INDIANA HARBOR BELT RAILROAD COMPANY

BULLETIN ORDER NO. S-32
Effective: 0600 Sunday September 02, 2018

August 31, 2018
General Orders in effect: NONE

13. Physical Characteristics Change Blue Island – IHB Main

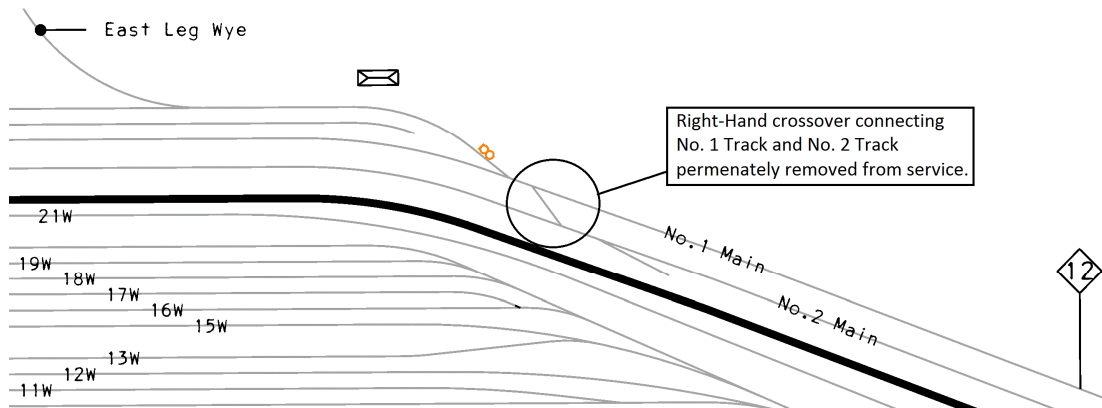
Effective 0600 07/17/2018 right-hand crossover connecting No. 1 Track and No. 2 Track permanently removed from service.

15. Physical Characteristics Change Blue Island West Yard – New Track Added

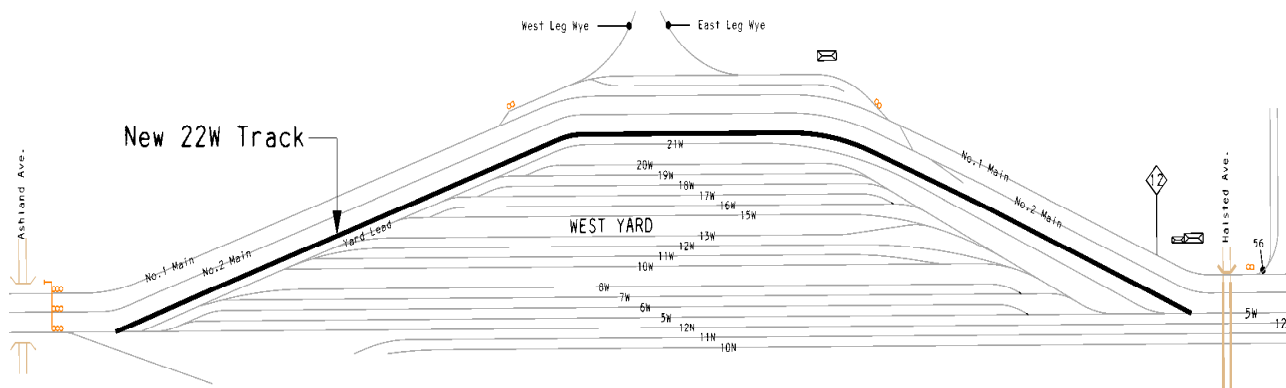
Effective 0600 07/12/2018 a new track 22 has been added to Blue Island West Yard. See diagram below reflecting this addition. Back Lead has been permanently removed from service. Employees and Foreign Line Crews must make notation to applicable sections in IHB Timetable and CORA Guide.
